## SERVICE BULLETIN

**APPLICABILITY:** 2018-24MY Ascent  
2019-24MY Outback & Legacy

**NUMBER:** 09-130-25

**SUBJECT:** Exhaust Manifold Flange Nut / Torque & Design Change

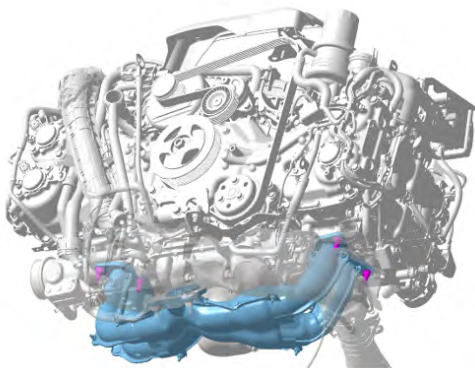
This bulletin announces the design change made to the exhaust manifold flange nuts. The material has been changed from a medium carbon steel to stainless steel. This change also necessitates a revised tightening torque specification. When replacement of the flange nuts is required, follow the part and service procedure information outlined in this bulletin.

EX-10326

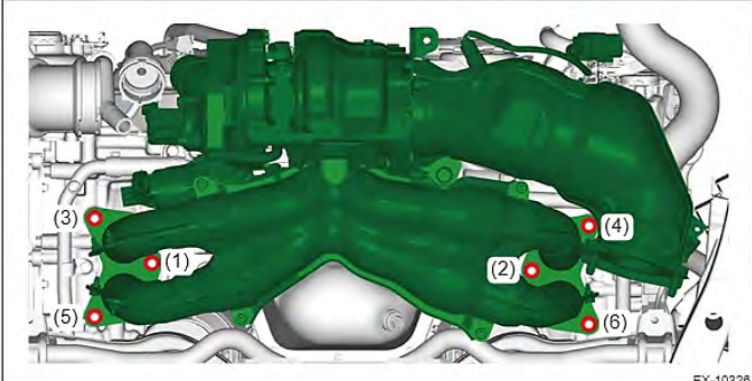
The torque procedure has been changed from a one-time torque of 65 Nm (6.6 kgf-m, 47.9 ft-lbs) to a two-step procedure with an initial torque of 55 Nm (5.6 kgf-m, 40.6 ft-lbs) then a final torque of 65 Nm (6.6 kgf-m, 47.9 ft-lbs). A section of the Service Manual is pictured below. The added service procedure (4.) has been outlined in **RED** and will be added to the applicable Service Manual in the future.

**Added Step**

**4.** Tighten the nuts in the numerical order as shown in the figure.  
**Tightening torque:**  
55 N·m (5.6 kgf-m, 40.6 ft-lb)

**5.** Tighten the nuts again in the numerical order as shown in the figure.  
**Tightening torque:**  
65 N·m (6.6 kgf-m, 47.9 ft-lb)
